Report to: Development Services Committee

Report Date: March 29, 2016

SUBJECT: RECOMMENDATION REPORT
Liberty Development Corporation
1 Steelcase Road West
South of Steelcase Road, west of Woodbine Avenue
Site Plan Approval Application to permit a 10 storey office
building with ground floor retail uses
File No.: SC 15 165979

NORTH ELEVATION

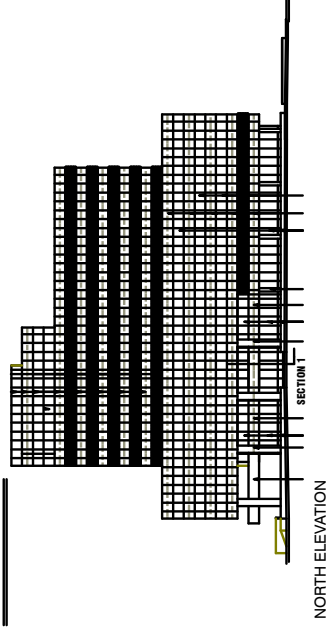
- improving site configuration to allow for an internal north-south connection that will provide access to future developable blocks along Woodbine Avenue;
- improving the location of access points, drop-off, entrances, loading, and underground access;
- improving the north elevation design and elevation treatments of the raised podium and ground floor;
- improving the public realm and streetscape condition along Woodbine Avenue;
- incorporate bird friendly, dark sky treatment and strategies to reduce the urban heat island effect;
- green roof design;
- incorporate other sustainability building and site design features; and
- parkland dedication requirement (land).
